**The Nature Conservancy in Arizona** Phoenix Conservation Center 7600 N. 15th Street, Suite 100 Phoenix, Arizona 85020-4330 Tel: [602] 712-0048 Fax: [602] 712-0059 The Nature Conservancy in New Mexico 212 East Marcy Street Santa Fe, NM 87501 Tel: [505] 988.3867 Fax: [505] 988.4905

August 20, 2012

Re: Comments on SunZia Transmission Line Project Draft EIS/RMPA

#### Figure 2. Habitat fragmentation in Arizona and New Mexico due to roads and transmission lines.

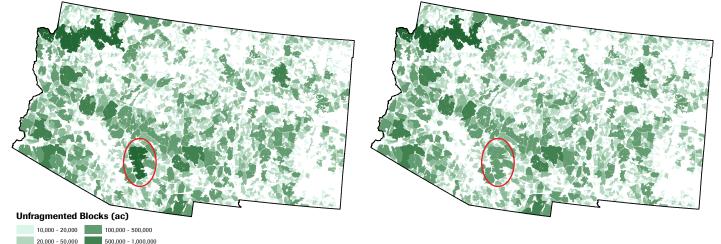
The remaining habitat blocks would also be compromised to the point where species and habitat recovery options would be limited. Figure 2 compares the current baseline condition to the future scenario. The largest remaining habitat blocks are indicated by progressively darker shades of green. The red polygon depicts the area encompassed by the Galiuro Mountains, Aravaipa Canyon, and Santa Teresa Mountains. The graphic to the right illustrates the change in size of this habitat block due to the proposed Aravaipa route of SunZia.

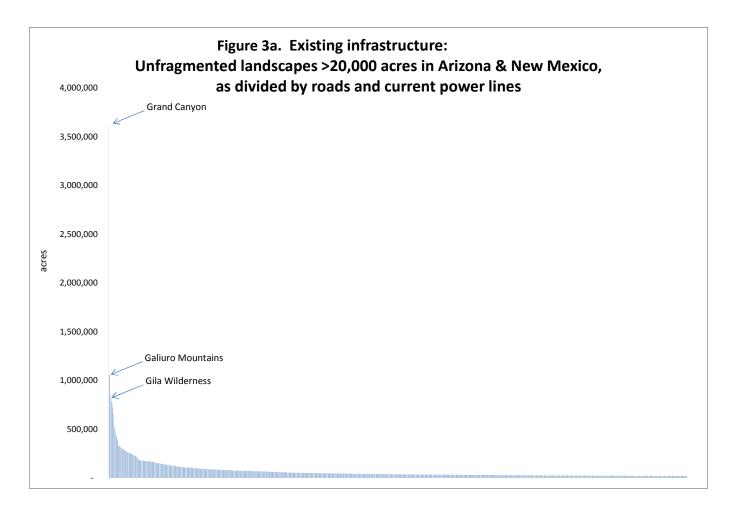
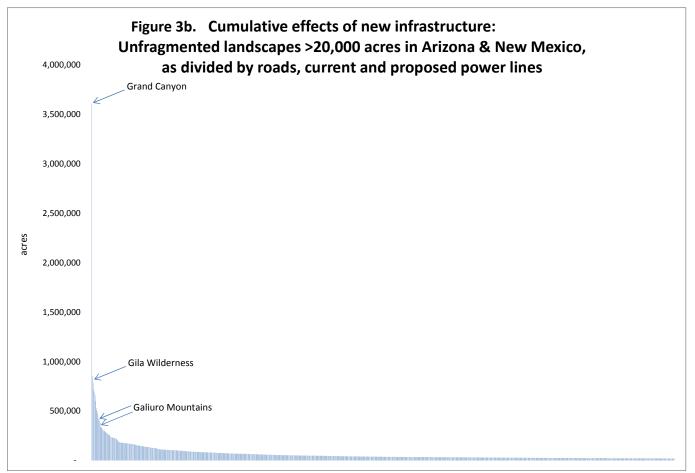
Figure 3 plots the distribution of habitat patch sizes in acres across Arizona and New Mexico. All patches smaller than 20,000 acres were excluded from the analysis to make the size of the graphic more manageable. Figure 3a illustrates how the current baseline condition is skewed considerably to the right, meaning the landscape of Arizona and New Mexico is comprised predominantly of small habitat fragments. This graphic also illustrates that outside of the Grand Canyon, there is no habitat block larger than the Galiuro-Aravaipa-Santa Teresa area. Figure 3b illustrates the change in ordinal position and size of the Galiuro-Aravaipa-Santa Teresa area from siting SunZia across the axis of this area.

While the impacts are less dramatic, other alternative routes for SunZia would also affect large blocks of currently unfragmented habitat. And as part of the cumulative effects, the other proposed lines would significantly shrink at least 25 additional habitat blocks that are currently larger than 20,000 acres.

The conclusion from these analyses is that the Sunzia transmission route proposed to cross the Galiuro-Aravaipa-Santa Teresa area would split in half the second largest unfragmented landscape remaining in the southwestern U.S. It would introduce habitat disturbance into an area where there are no paved roads, no dirt roads over the Santa Teresas into the Gila River Valley, and only one nearly-impassable jeep trail that crosses over the axis of the Galiuros from Aravaipa Valley to the San Pedro River Valley. With the Southwest's largest remaining intact area, the Grand Canyon, already in protected status, it raises the question of whether mitigation measures are even possible for disturbances to the region's second largest intact landscape.

Figure 4. Prescribed fire burn units for the BLM South Rim Allotment. SunZia route added for clarity.

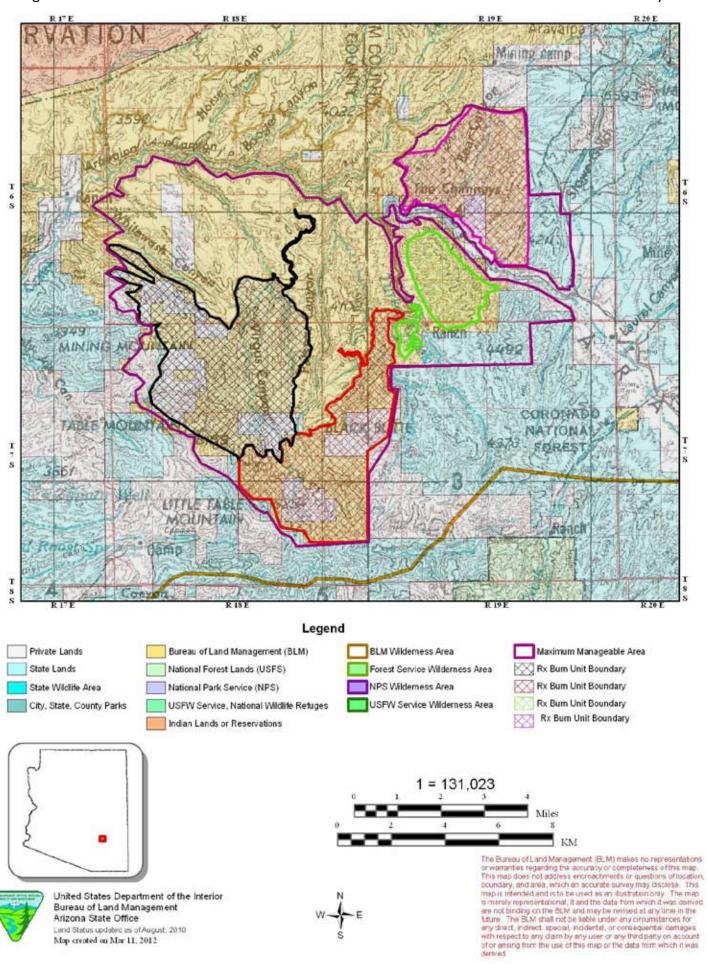
As acknowledged in the DEIS (Section 4.17.4.7), placement of transmission lines across the Galiuros would severely limit, if not entirely preclude, the use of fire as a management tool to maintain and enhance habitat for wildlife. This is due to the significant liabilities transmission providers face if they incur outages through lack of vegetation management and the hazards a transmission line creates for fire crews. Along with fragmentation effects of transmission lines, the exclusion of fire from habitats historically maintained by fire will result in habitat loss for species dependent upon grassland and forested habitats. Moreover, limiting the use of fire as a management tool increases the chance of catastrophic wildfire in an area with few roads and limited access for fire suppression activities, which would introduce a constant threat for any new infrastructure. Use of fire is the only practical tool to manage habitat for an area of this size. The lack of extensive infrastructure in this area has made habitat management using fire practical, something that has become increasingly difficult to accomplish elsewhere as urban, suburban, and exurban development encroach into prime wildlife habitat throughout the state's forests and grasslands.

While the Galiuro route would cross only state and private lands, its close proximity to federal lands would affect fire management across much larger areas where fire planning already exists. The Galiuro Mountains and upland areas south of Aravaipa Canyon were identified as areas suitable for wildland fire use for resource management benefit in the BLM (2004a) Arizona Statewide Land Use Plan Amendment for Fire, Fuels, and Air Quality Management, and in the BLM (2004b) Safford-Tucson Fire Management Plan. There is a similar policy in the Coronado National Forest (2010) Fire Use Management Plan. Similar policies were stated in the Muleshoe Ecosystem Management Plan (BLM 1998), which sets out a prescribed fire program using both natural and deliberate ignitions to restore and maintain upland vegetation throughout most of the Galiuro Mountains. Similar guidance was presented in the draft Aravaipa Ecosystem Management Plan (BLM 2010). An existing BLM prescribed fire burn unit is within one mile of link C170 (Figure 4; SunZia route added).

- Establish clear multi-agency agreements that wildland fire use in the Galiuro Mountains, using both natural and prescribed ignitions, would not be constrained.

#### Figure 5.

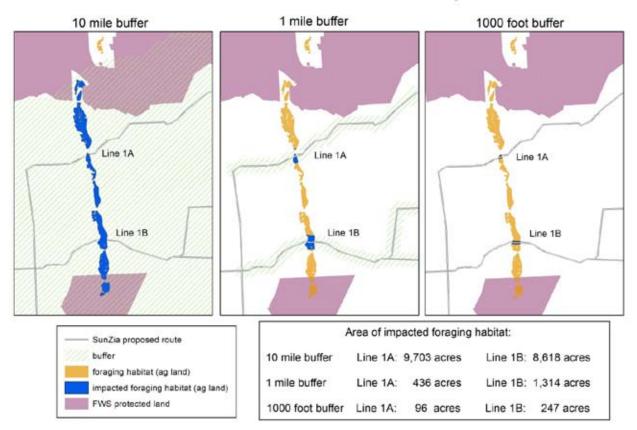
We evaluated foraging habitat potentially impacted by the proposed alternatives. Figure 5 summarizes the acreage of foraging habitat within three different buffer distances from the proposed transmission lines, to estimate both indirect and direct losses. The largest buffer distance is 10 miles and is based on a study by Lewis (1976) which found that optimal roosting sites are located within 10 miles of feeding areas. The second buffer distance of 1 mile is based on the current U.S. Fish and Wildlife Service best management practices (BMP) for minimizing whooping cranes impacts. This BMP recommends that diverters be placed on all transmission within 1 mile of roosting sites. A 1,000-foot buffer was also evaluated to show the direct losses expected from conversion of foraging habitat within the construction corridor.

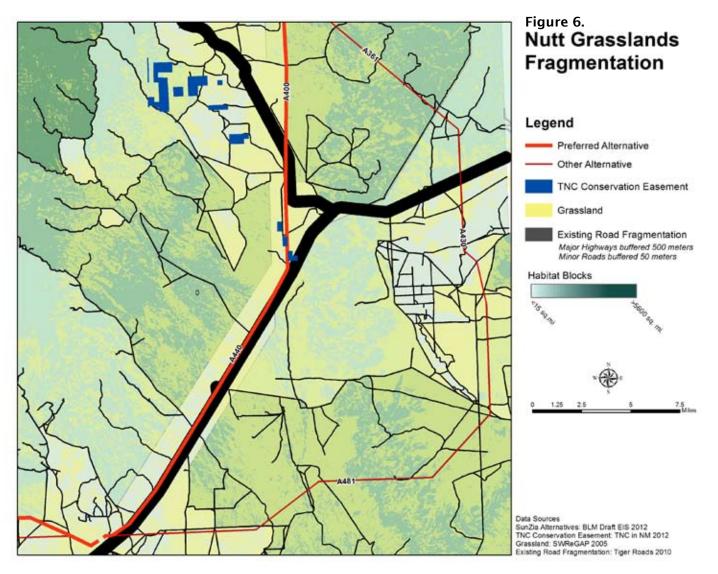
The alternatives of Route group 1 will impact the relatively unfragmented Nutt Grasslands in northeastern Luna County and will cross The Nature Conservancy's Double Lightning Conservation Easement. Construction of new utility towers is prohibited in the terms of this easement. The

fragmentation analysis displayed in Figure 6 shows that the BLM preferred alternative (Links A400, A440) follows the best path through the area to minimize fragmentation. However new renewable energy development associated with the transmission line project could present additional fragmentation problems.

- 1) Minimize site disturbance to grasslands and replant/restore any grasslands impacted with native seed and follow best management practices recommended by the United States Department of Agriculture to prevent introduction and spread of invasive plants (<u>http://www.invasivespeciesinfo.gov/plants/prevention.shtml</u>)
- 2) SunZia should follow mitigation recommendations outlined in the "Suggested Practices for Raptor Protection on Power Lines" (APLIC 2006) in the Design, Construction and Operation phases. Effective implementation of an Avian Protection Plan is important in all three phases.
